Work Order ID 72492

Item Name: Crosstube Turning Detail

DART AEROSPACE LTD	Work Order: 72492
Description: Crosstube Assembly	Part Number: D407-667-245
Inspection Dwg: D407-667-245 Rev: F	Page 1 of 1

DRAWING NO. D407-667-245	TITLE CROSSTUBE ASSY (407 HIGH AFT)	REV. F	DART AEROSPACE LTD ENGINEERING ORDER		D.E.O. NO. D407-667-245-F-1	SHEET NO. SHEET 1 OF 2	SCALE NTS
DRAWN <i>J</i>	CHECKED <i>97</i>	MFG. APPR. <i>E</i>	APPROVED <i>140</i>	DE APPR. <i>H</i>			
DATE 11.04.08	DATE 11.04.12	DATE 11.04.12	DATE 11.04.12	DATE 11-04-12

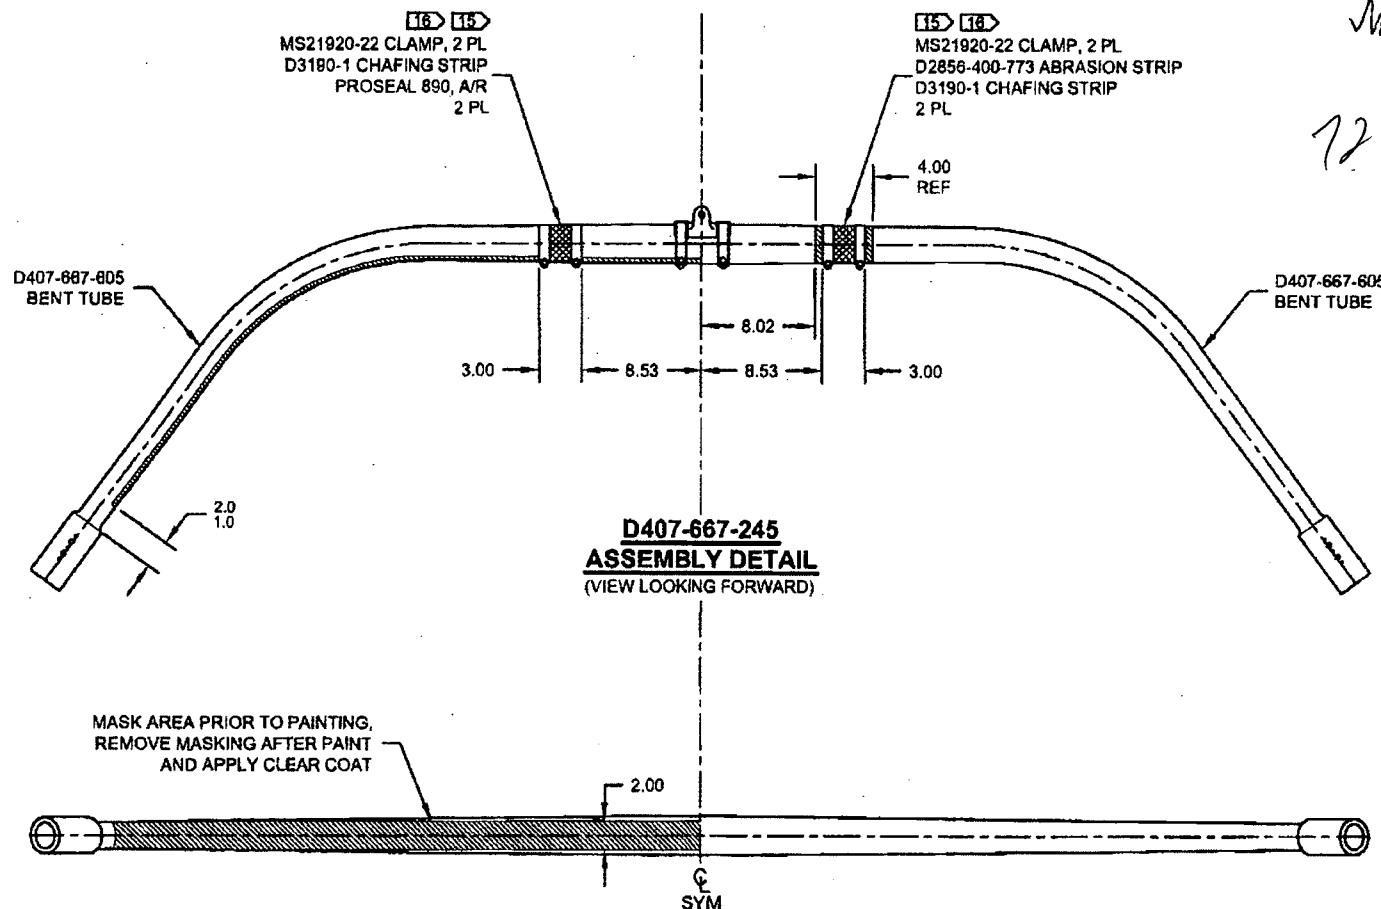
PURPOSE:

REMOVED ABRASION STRIP IN FAVOR OF A THIN LAYER OF PROSEAL 890.

CHANGE:

PARTS LIST IS AMENDED AS FOLLOWS:

NOTES 2 AND 15, SHEET 1 ARE AMENDED AS FOLLOWS:

IS:

Item	Qty -245	Part Number	Description
3	0	D2856-400-773	ABRASION STRIP

WAS:

3	2	D2856-400-773	ABRASION STRIP
---	---	---------------	----------------

IS:

- 2) FINISH: CHEMICAL CONVERSION COAT PER DART QSI 005 4.1
PRIME INSIDE AND OUTSIDE PER DART QSI 005 4.2
MASK UNDERSIDE OF CROSSTUBE AS SHOWN (HATCHED AREA) AND
PAINT OUTSIDE PER DART QSI 005 4.2
REMOVE MASKING AND APPLY CLEAR COAT
- 15) APPLY A THIN COAT OF PROSEAL 890 ON INSIDE CONCAVE SURFACE OF D3190-1
CHAFING SHIELDS AND LET CURE PER MANUFACTURER'S INSTRUCTIONS. INSTALL
PROSEAL D3190-1 CHAFING SHIELDS ONTO CROSSTUBE BY APPLYING A THIN COAT
OF PROSEAL 890 ONTO CROSSTUBE. BE SURE TO ELIMINATE ANY AIR GAPS.

WAS:

- 2) FINISH: CHEMICAL CONVERSION COAT PER DART QSI 005 4.1
PRIME INSIDE AND OUTSIDE PER DART QSI 005 4.2
PAINT OUTSIDE PER DART QSI 005 4.2
- 15) INSTALL D2856-400-773 ABRASION STRIP WITH A 0.13 REF GAP ON BOTTOM SIDE OF
CROSSTUBE PER QSI 035.
